PRIVATE PLAN CHANGE 91
ADDENDUM HEARING REPORT
80 MCLARIN ROAD, GLENBROOK BEACH
HD PROJECT 2 LIMITED

Hearing Report (Addendum) for Proposed Private Plan Change 87 : 301 and 303 Buckland Road, Pukekohe to the Auckland Unitary Plan (Operative in Part)

Report to:	Hearing Commissioners
Hearing Date/s:	15 (and 16) November 2023
File No:	Hearing Report (Addendum) – Proposed Private Plan Change 87 (PC87)
File Reference	S42A Report (Addendum) PC91
Report Author	Katrina David, Senior Policy Planner, Plans and Places
Report Approvers	Craig Cairncross, Team Leader Central and South Planning, Plans and Places
Report produced	10 November 2023

Figure 1: Showing area where Standard IXXX.6.2.2 applies

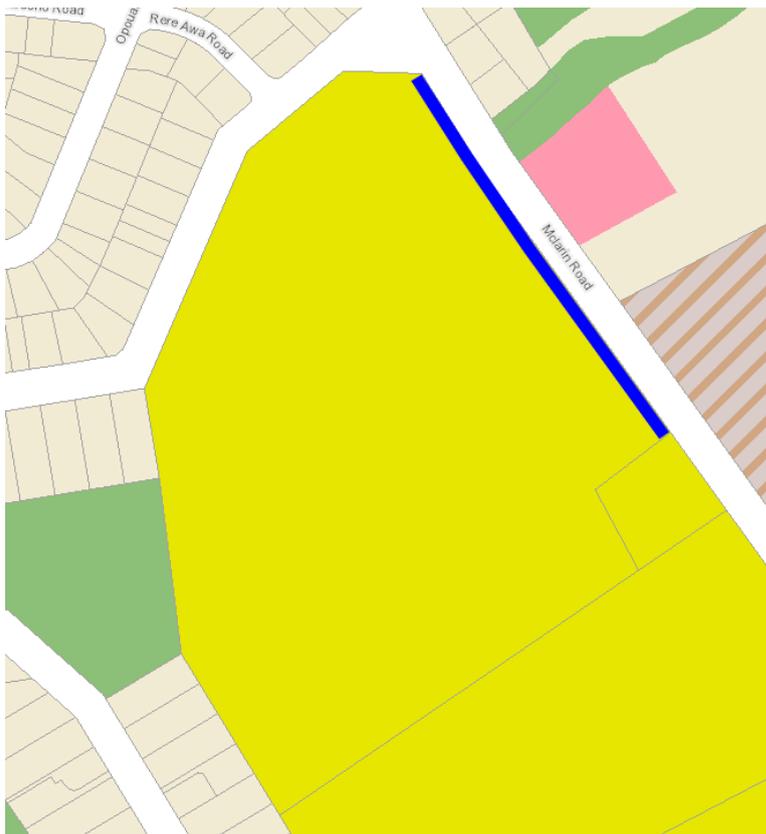
41. I rely on the advice of Mr Edwards. However I see the potential issue Mr Smallburn has highlighted and agree the standard could be better drafted or the precinct plan could be amended to make it clearer that the standard only applies to subdivision or development that fronts the portion of McLarin Road shown by the blue line on the figure below.

42. Overall I retain my position on the recommended precinct provisions in relation to the McLarin Road roundabout and pedestrian crossing facility set out in the Section 42A Report including these listed below, noting possible further amendments:
